Change of labels for EPCOS DeltaCap capacitors

Product / Process Change Notification

1.	. ID No.: FILM P18-11 2. Date of announcement: July 6, 201		ent: July 6, 2018			
3.	Product / product group:	Old ordering code:	New ordering code:	Customer part number:		
	EPCOS DeltaCap™ MKD	B32300*	n/a	n/a		
		B32301*				
		B32302*				
		B32303*				
		B32304*				
		B32305*

Annex to UPtoDATE 180706PC1 of July 6, 2018 / Change of labels for EPCOS DeltaCap™ capacitors

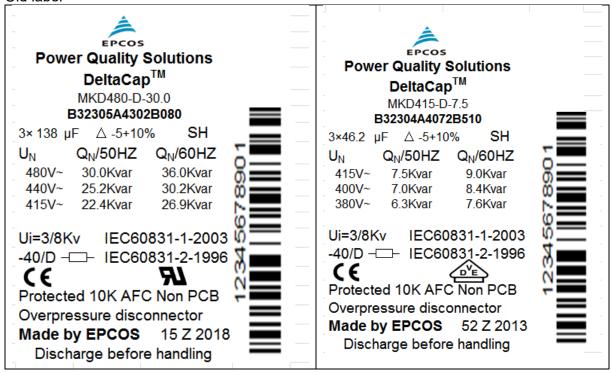
4.	Description of change:					
	Since IEC directives have clabels will now show:	since IEC directives have changed, the labels for DeltaCap MKD capacitors will be updated accordingly. abels will now show:				
	IEC 60831-1:2014 (before change: IEC 60831-1-2003)					
	IEC 60831-2:2014 (before c	EC 60831-2:2014 (before change: IEC 60831-2-1996)				
	Example enclosed.
